EMDF Comments Primarily Related to the Site Groundwater Characterization Fact Sheet
Due DOE June 7, 2022

Subject: Comments primarily related to the Site Groundwater Characterization fact sheet

Deep Piezometer GW-982 screened from 102.1 - 112.1 ft-bgs (elevation 913.5 - 903.5 ft)
Shallow Piezometer GW-983 screened from 79.1 - 89.2 ft-bgs (elevation 936.4 - 926.4 ft)

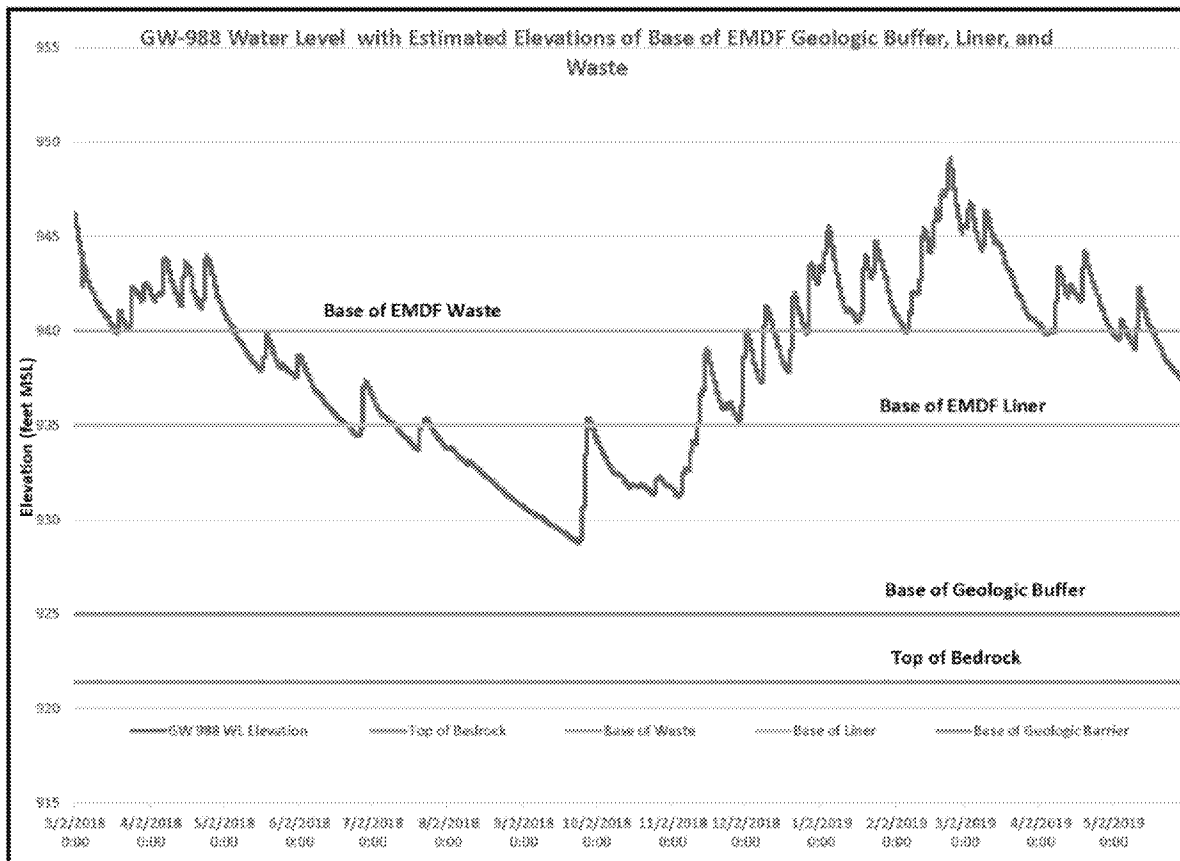
The two well pairs in areas of proposed excavation on the knoll for proposed Cells 1 and 2, under current conditions groundwater conditions show groundwater levels are sufficient to impact the geologic buffer year round and to impact the geomembrane liner and rise into the waste zone at certain times of the year. Please see the following figures. Top of bedrock in the following figures was estimated from borehole log auger refusal in borehole logs included in TM#2.

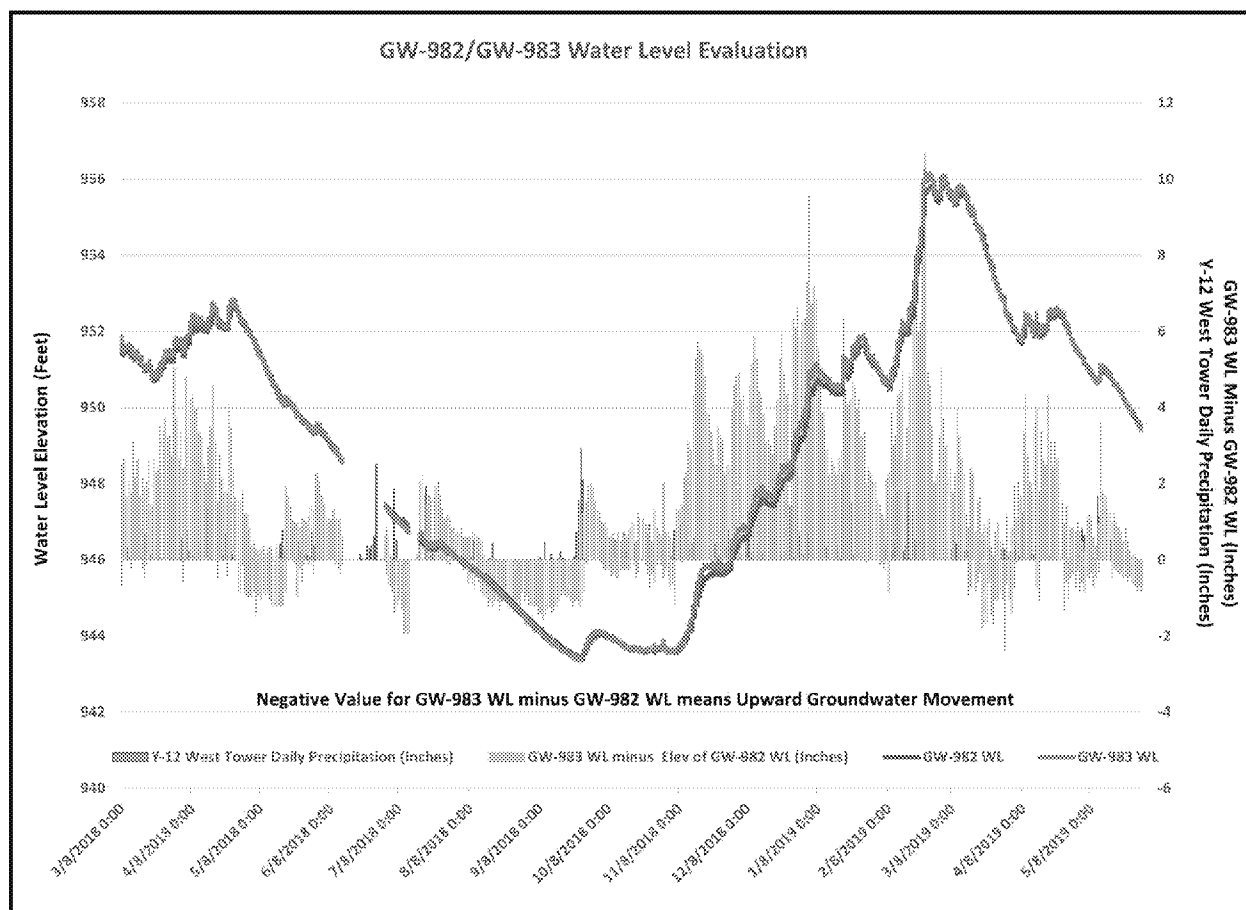
The following figure derived by comparing water level data collected for TM-2 and available in OREIS for deeper and shallower piezometers GW-982/GW-983, shows that in addition to rising groundwater in the GW-982/GW-983 area during September 2018 dry conditions noted in TM-2 Table 7.3, under current conditions rising groundwater based on water levels was also recorded in TM-2 data up to an elevation of about 955 feet.

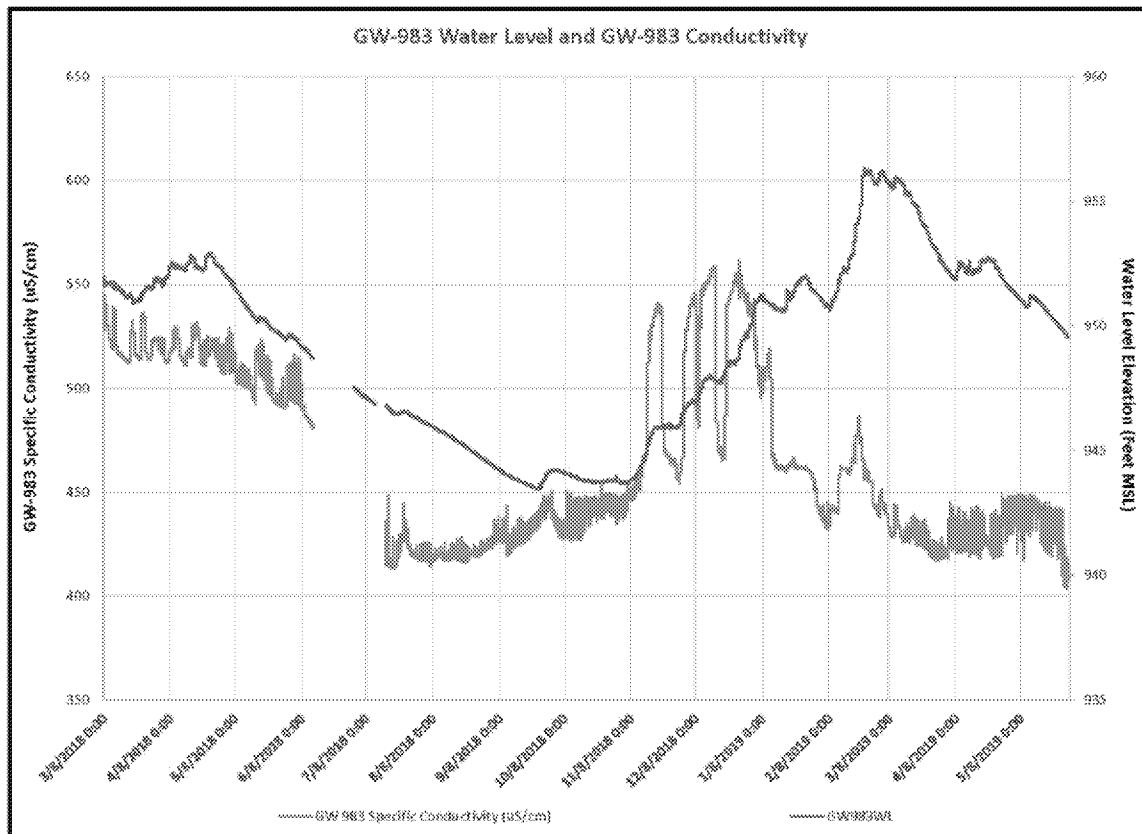
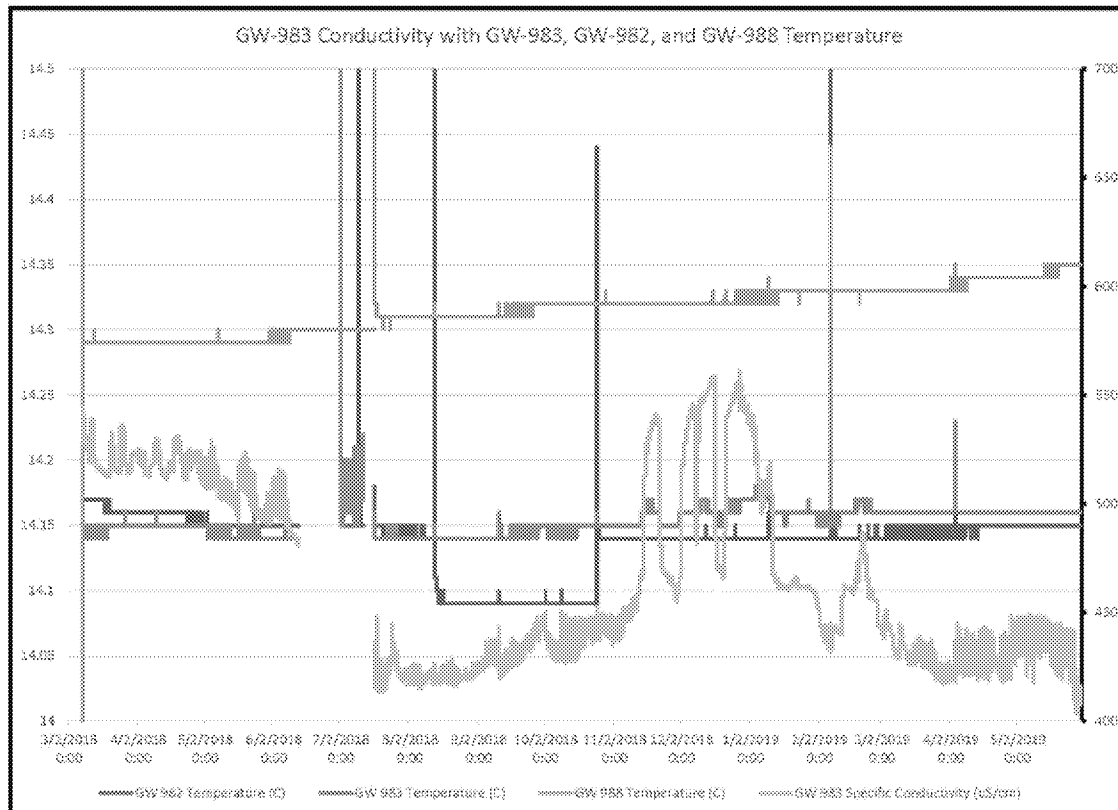
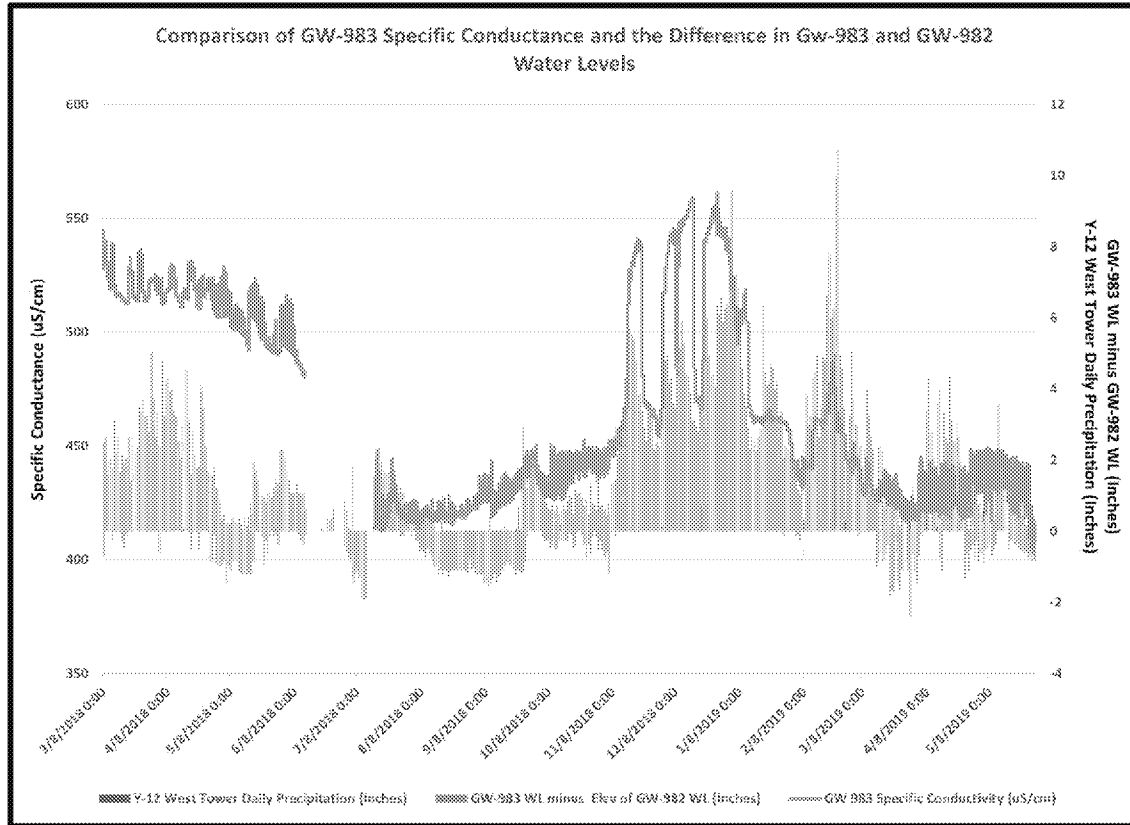
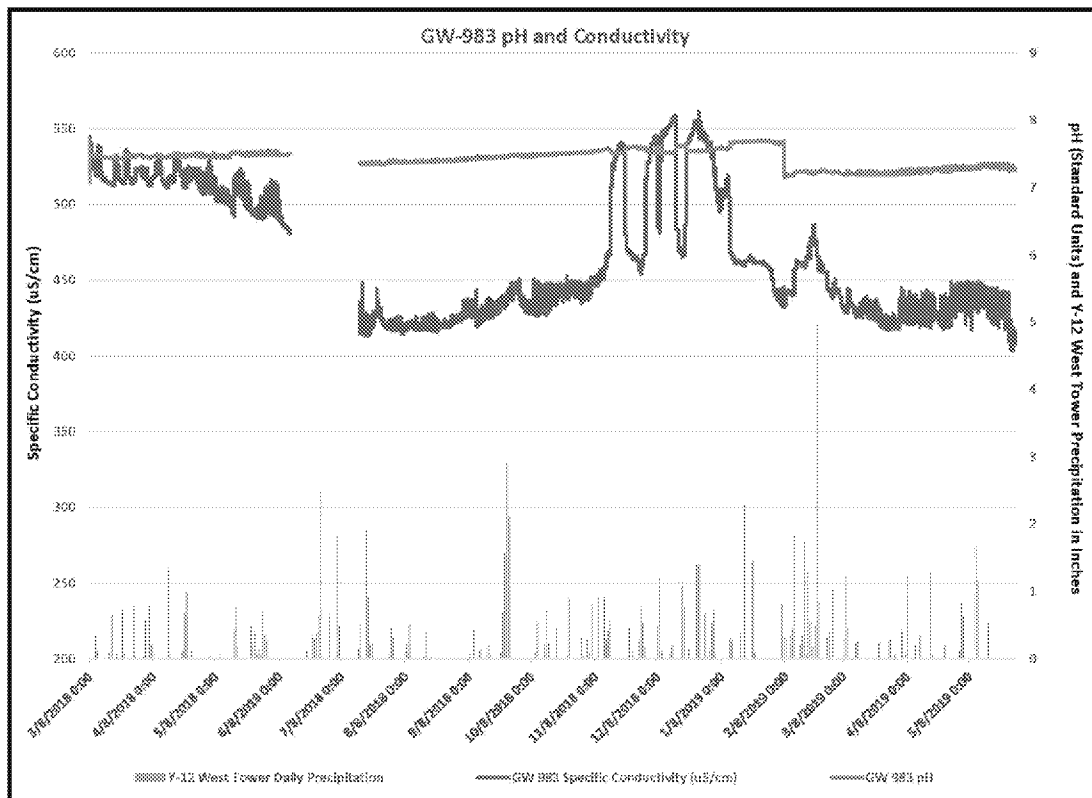
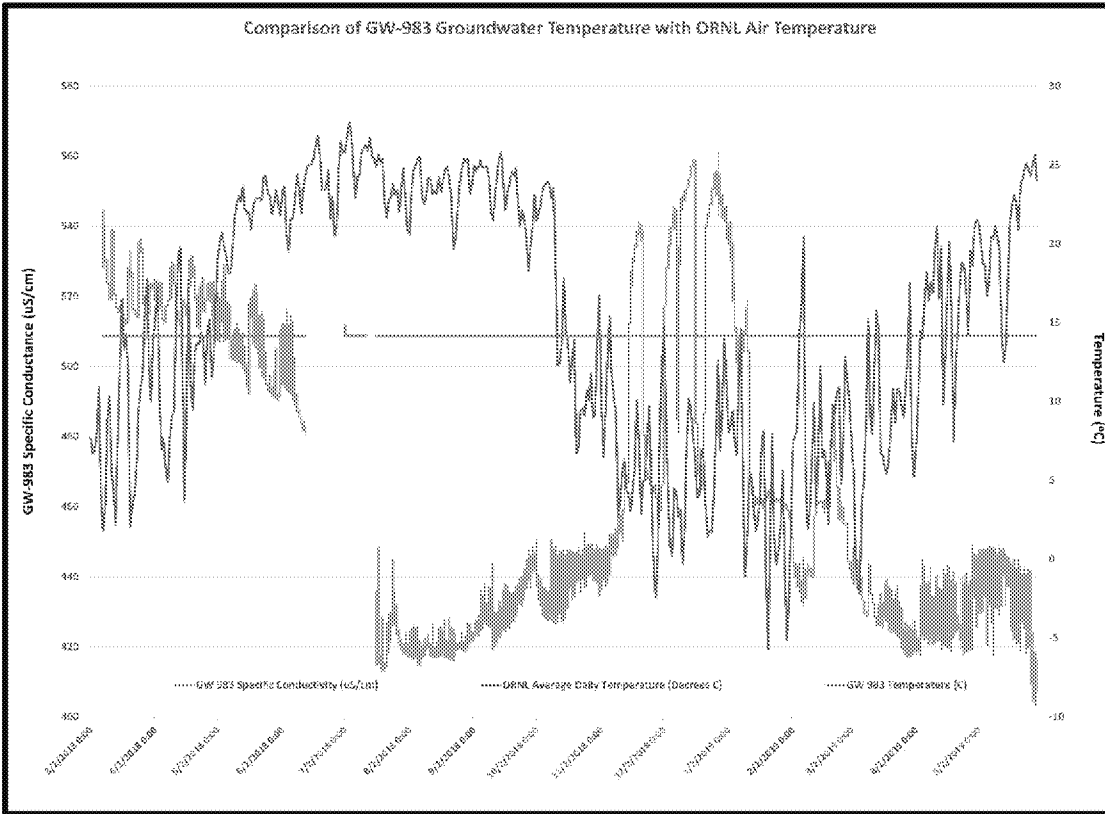
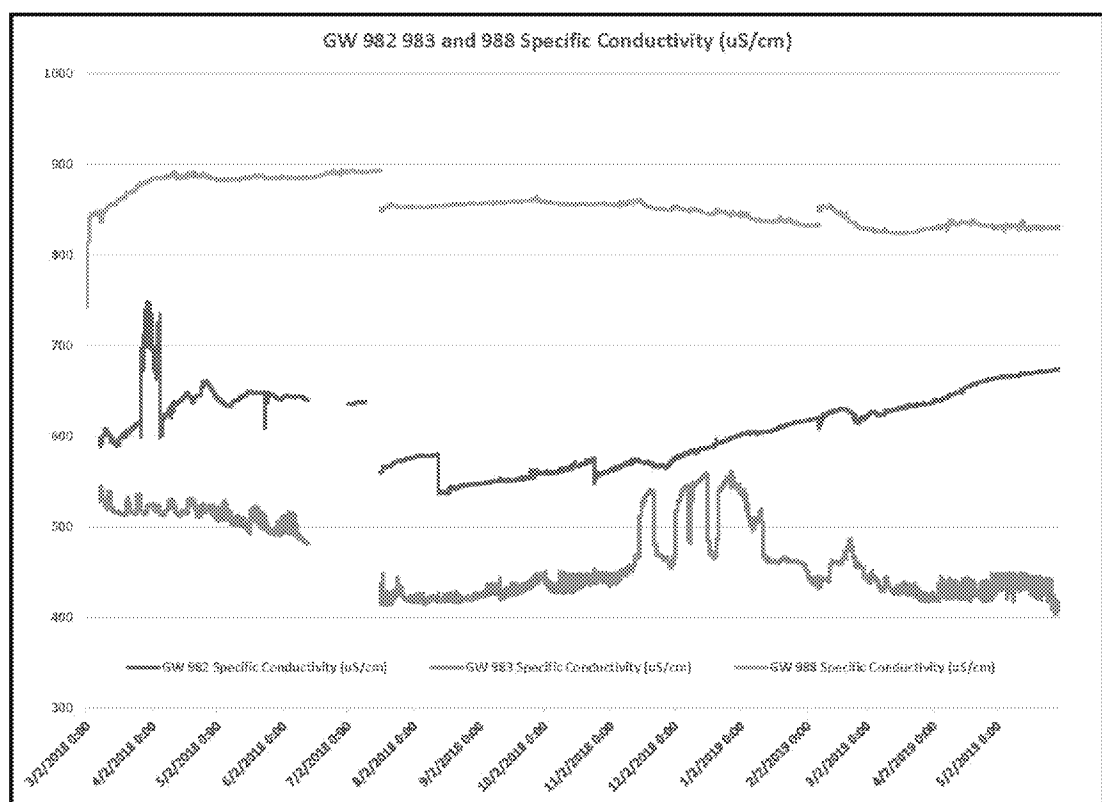
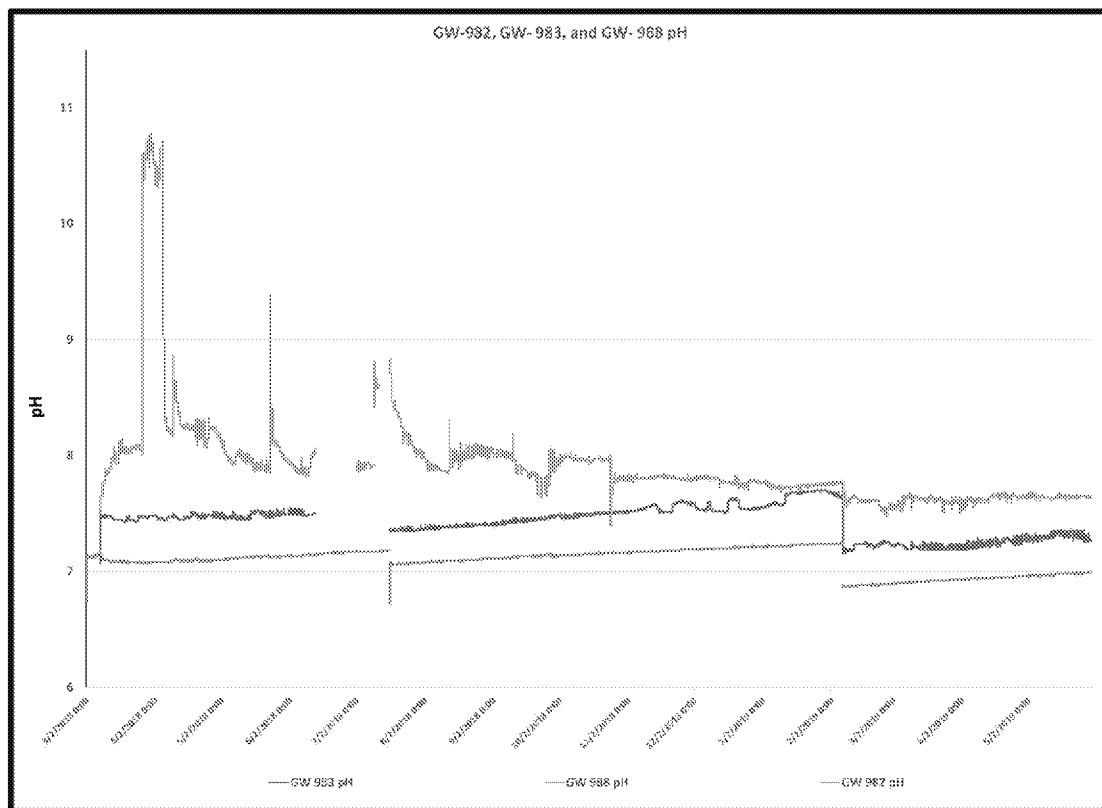
- 4) In addition to water level data, electrical conductivity, pH, and temperature data were also collected for TM#2. The following figures include:
 - a) GW-983 electrical conductivity overlain on GW-983 water level;
 - b) GW-983 electrical conductivity (specific conductance) overlain on the difference of water levels derived by subtracting the elevation of the water level in GW-982 from the elevation of the water level in GW-983;
 - c) GW-983 electrical conductivity overlain over groundwater temperatures measured in GW-983, GW-982, and GW-988;
 - d) Comparison of GW-983 groundwater temperature with air temperature measured at ORNL;
 - e) GW-983 groundwater electrical conductivity overlain on GW-983 pH;
 - f) Comparison of GW-982, GW-983, and GW-988 pH; and
 - g) Comparison of GW-982, GW-982, and GW-988 electrical conductivity (i.e., specific conductance).

- Increased electrical conductivity (i.e., specific conductance) in GW-983 observed from about November through March is real and is generally associated with an increase in groundwater temperature and a decrease in groundwater pH.

- November through March are colder months and both air temperature at ORNL and groundwater temperature for deeper piezometer GW-982 have temperatures lower than the high conductivity groundwater entering GW-983. Increased temperature of groundwater associated with the higher electrical conductance groundwater during late fall and winter shows the source of the influx of higher electrical conductance groundwater is neither GW-982 nor infiltrating rainwater.

- Deeper piezometer GW-982 also has a higher pH than GW-983, so again it's not the source of lower pH groundwater entering GW-983.
- The higher electrical conductivity groundwater entering GW-983 appears more like groundwater measured in GW-988 than either rainwater or GW-982.

This analysis concludes the higher electrical conductivity, lower pH, higher temperature groundwater that entered GW-983 during late fall and winter 2018/2019 is real, not bad data, and was neither infiltrating rainwater nor GW-982 groundwater. Where electrical conductivity begins to drop off in January and February may be due to dilution from infiltrating rainwater.

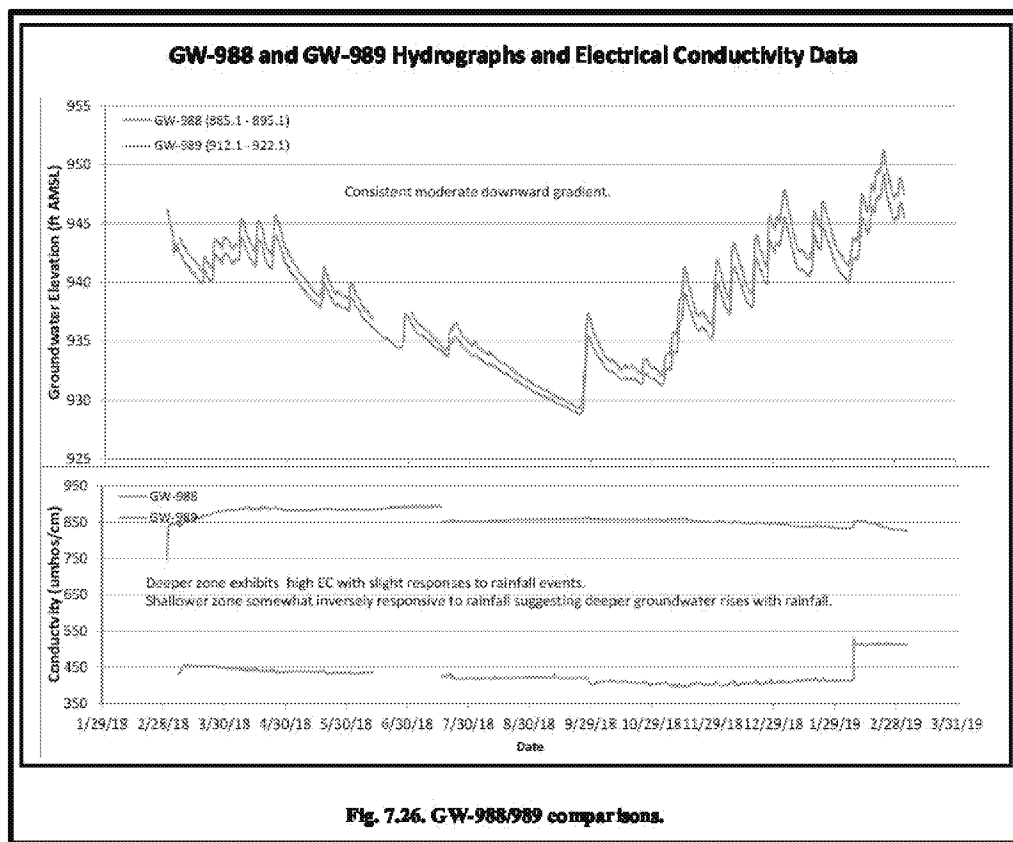
- 6) Piezometer pair GW-988 and GW-989 possibly drilled through a fault(s). Borehole descriptionsⁱⁱ of bedding turning from a 45-degree dip to near vertical with additional discussion of slickensides perpendicular to bedding, some limestone beds being highly deformed to almost brecciated, and possibly slightly overturned beds appear to indicate faulting. In this case both deep piezometer GW-988 and shallow piezometer GW-989 are screened in or near potentially faulted intervals. Shallow piezometer GW-989 sand pack also appears to across the saprolite bedrock contact allowing shallow groundwater at the saprolite bedrock contact to enter the piezometer. TM-2 also includes the following figure with a statement suggesting deeper groundwater rises with rainfall.
